Technical Service Bulletin

SUBJECT:		No: TSB-19-13-003	
ENGINE DOES NOT RESTART AND/OR FAILSAFE MODE OCCURS DUE TO FROZEN RELAYS - REVISED		DATE: April 2019	
		MODEL: See below	
CIRCULATE TO:	<input type="checkbox"/> GENERAL MANAGER	<input checked="" type="checkbox"/> PARTS MANAGER	<input checked="" type="checkbox"/> TECHNICIAN
<input checked="" type="checkbox"/> SERVICE ADVISOR	<input checked="" type="checkbox"/> SERVICE MANAGER	<input checked="" type="checkbox"/> WARRANTY PROCESSOR	<input type="checkbox"/> SALES MANAGER

This bulletin supercedes TSB-18-13-003, issued December, 2018, to add Eclipse Cross, applicable Canadian models, and countermeasure dates. Revisions are italicized and indicated by ◀.

Eclipse Cross (2018-2019) Relay Locations

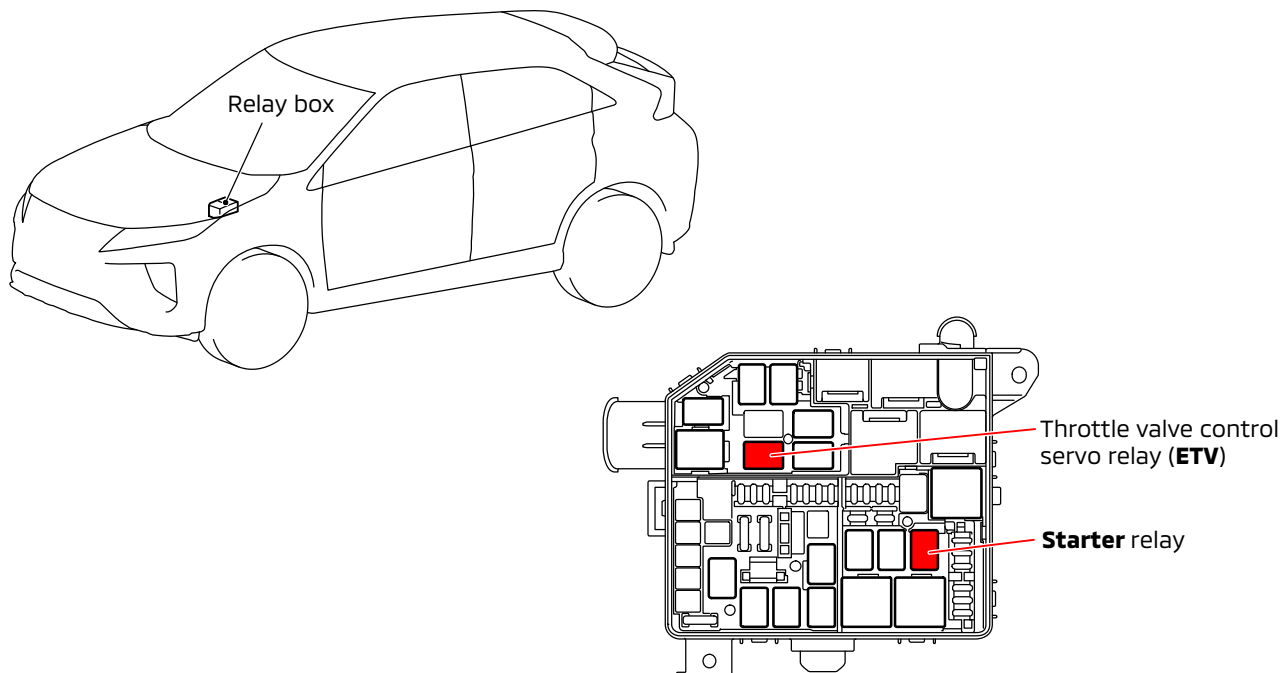
RELAY	DTC	SYSTEM	SYMPTOM
ETV	C121C	ASC	Rough idling, no revolution up
	C1707		
	P0657	ENGINE	
STARTER	P0616	ENGINE	No acceleration, no shifting

▶ **If ALL DTCs listed above are present for the systems shown, replace the following relays with the anti-freezing type listed below.**

RELAYS TO REPLACE	PART NUMBER (anti-freezing type)	PART NAME	RELAY TYPE	QTY
ETV	8627A049	RELAY, POWER	Micro ISO	1
STARTER				1

Lancer Evolution Relay Locations

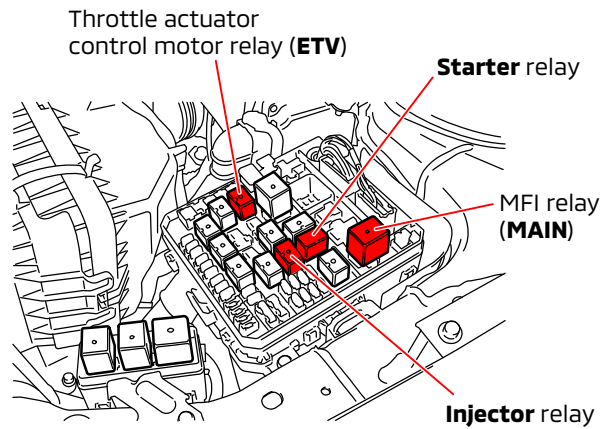
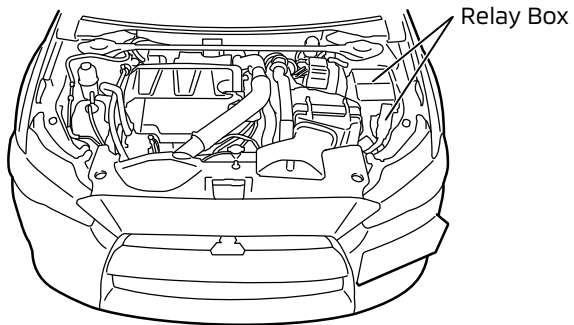
RELAY	DTC	SYSTEM	SYMPTOM
MAIN	U0100	ASC, CVT, ETACS, EPS	Engine does not start
	C1290	ASC	
	P1561	EPS	
ETV	U1417	ASC	Rough idling, no revolution up
	C121C		
	P0657	ENGINE	
A/T (CVT)	U0101	ASC, ETACS, ENGINE	No acceleration, no shifting
	C1290	ASC	
	P1590	ENGINE

If ALL DTCs listed above are present for the systems and vehicles shown, replace the following relays with the anti-freezing type listed below.

RELAYS TO REPLACE	PART NUMBER (anti-freezing type)	PART NAME	RELAY TYPE	QTY
MAIN	8627A050**	RELAY, POWER	Mini ISO	1
ETV	8627A049***		Micro ISO	1
A/T (CVT)*				1
INJECTOR				1
STARTER				1

Outlander (2014-2019) Relay Locations

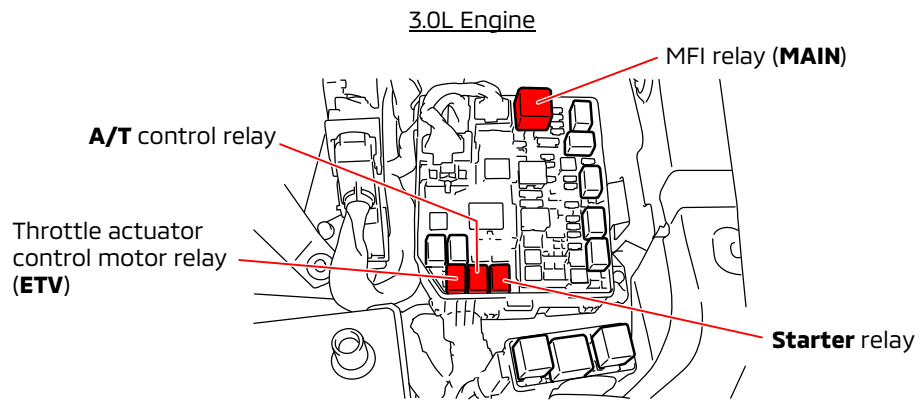
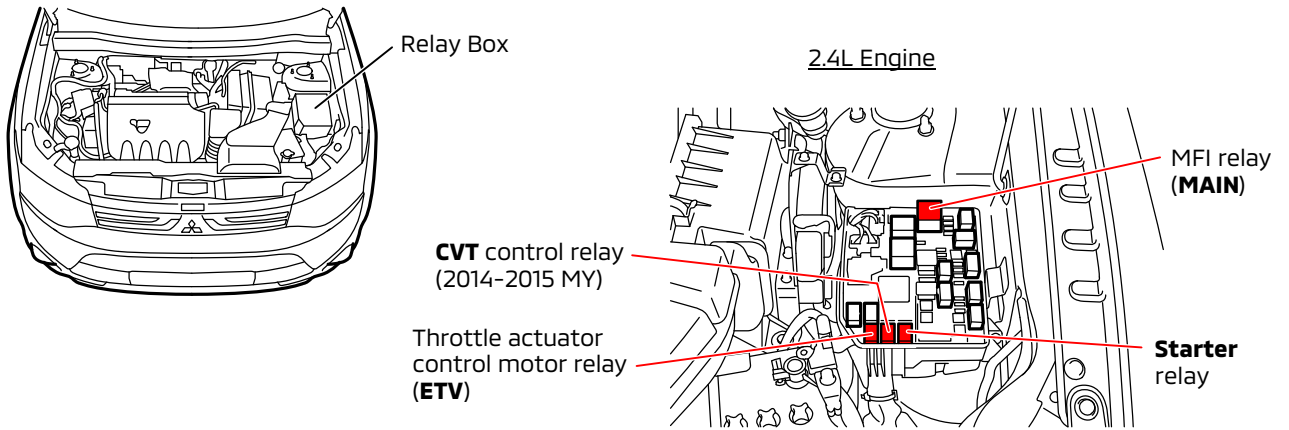
RELAY	DTC	SYSTEM	SYMPTOM
MAIN	U0100	ASC, CVT, ETACS, EPS, AWC	Engine does not start
	B1731*	ETACS	
	P1561	EPS	
	C1632	AWC	
	U15A4	OSS	
	U15A2		
ETV	C121C	ASC	Rough idling, no revolution up
	C1707		
	P0657	ENGINE	
A/T (CVT)	U0101	ASC, ETACS, ENGINE, AWC	No acceleration, no shifting
	P1590	ENGINE	
	C1633	AWC

If ALL DTCs listed above are present for the systems shown, replace the following relays with the anti-freezing type listed below.

RELAYS TO REPLACE	PART NUMBER (anti-freezing type)	PART NAME	RELAY TYPE	QTY
MAIN	8627A050**	RELAY, POWER	Mini ISO	1
ETV	8627A049***		Micro ISO	1
A/T (CVT)*				1
STARTER				1

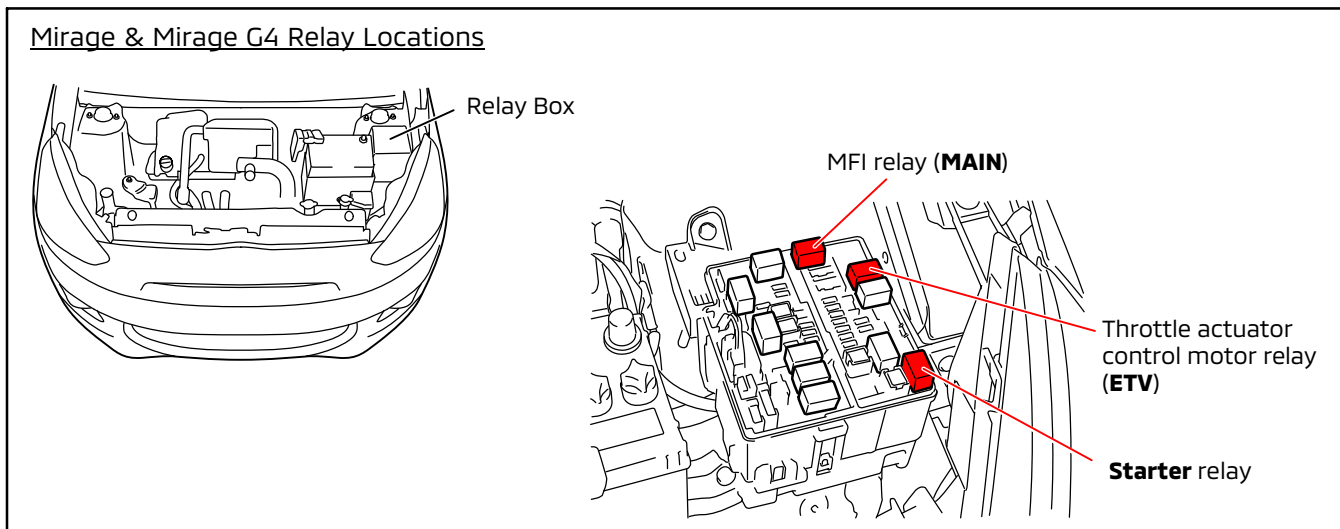
RELAY	DTC	SYSTEM	SYMPTOM
MAIN	U0100	CVT, EPS, KOS/OSS	Engine does not start
	U1100	ASC, ETACS	
	C1560	EPS	
	B1138	KOS/OSS	
	B1731		
ETV	C1396	ASC	Rough idling, no revolution up
	P0657	ENGINE	
STARTER	P1612	ENGINE	Engine does not start
	B1132	KOS/OSS

If ALL DTCs listed above are present for the systems and vehicles shown, replace the following relays with the anti-freezing type listed below.

RELAYS TO REPLACE	PART NUMBER (anti-freezing type)	PART NAME	RELAY TYPE	QTY
MAIN	8627A049*	RELAY, POWER	Micro ISO	1
ETV				1
STARTER				1
